# RENESAS TECHNICAL UPDATE

| Product<br>Category   | MPU/MCU  | Document<br>No. | TN-V85-A003A/E                                    | Rev.   | 1.00 |  |
| Title                 | V850ES/Kx1, Kx1+ Restriction notification of Mask ROM products   |                 | Information<br>Category                           | Technical Notification   |      |  |

(Example) The pipeline disordered is generated by Alignment hazard:

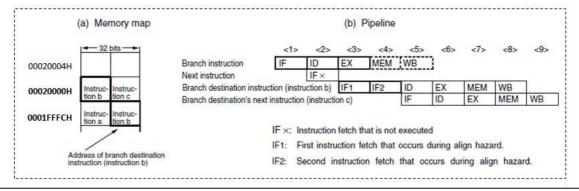
In the case of Applicable Usage, CPU executes the wrong instruction code.

In this case, the instruction b will not be executed correctly. And wrong instruction code is executed.

To avoid the continuous execution of Instruction codes which addresses from 001FFFCH to 0020000H, please allocate 16 bytes data of all "0" in the address of 001FFF0H to 001FFFFH.
